18.07.2016 No. 01-18

This service bulletin is applicable for all Tercel's gyrocopter.

SUBJECT

Bowden flexible cable holder replacement.

Fig. 1

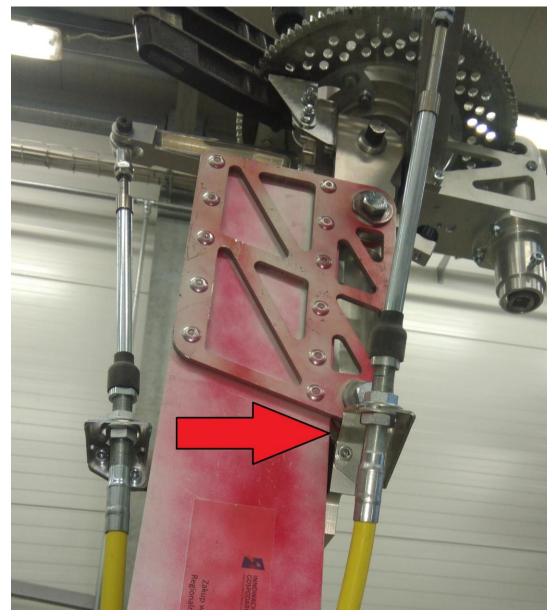
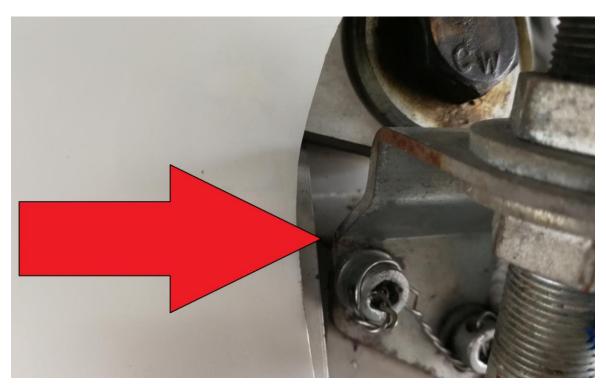
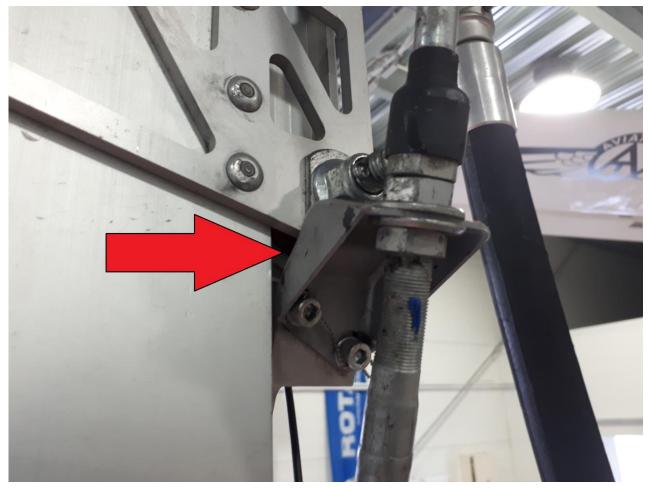
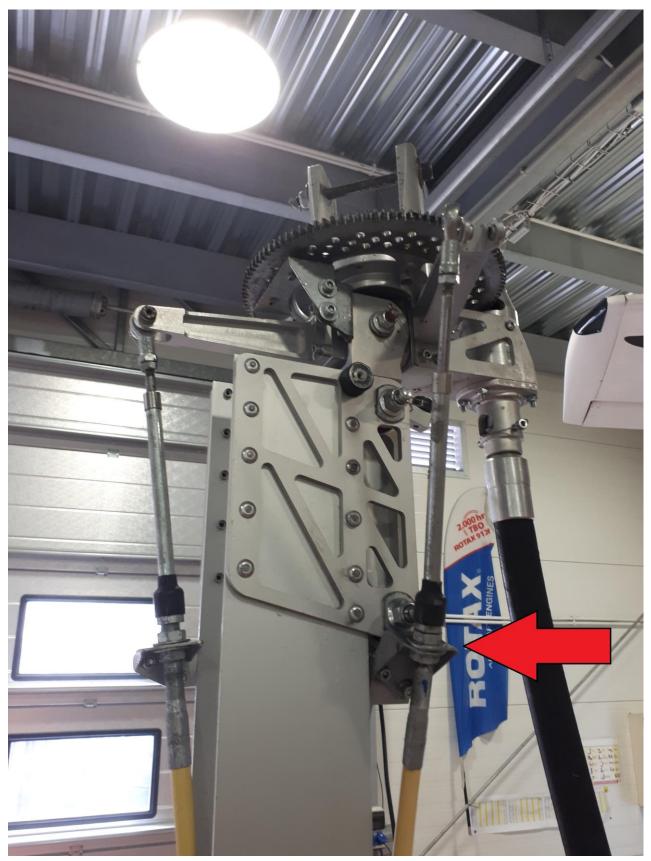
1) Check the holder in gyrocopter. Holder to be replacement is shown on pictures below [Fig. 1] and [Fig. 2].

The new, improved holder are on the following figures [Fig. 3] and [Fig. 4].

There is one main difference between these holders: the new one has reinforcing rib.

Holder without rib have to be immediately replaced.

- 2) There is no need to implement this bulletin If the gyrocopter has the new holder with reinforcing rib.
- 3) In case of an holder without rib, please check it before and after every flight.
 If any crack or permanent deformations are found, the gyrocopter can not be operated!
- 4) If the gyrocopter has holder without reinforcing rib please immediately contact with manufacturer Aviation Artur Trendak for further information: service manual and spare parts.
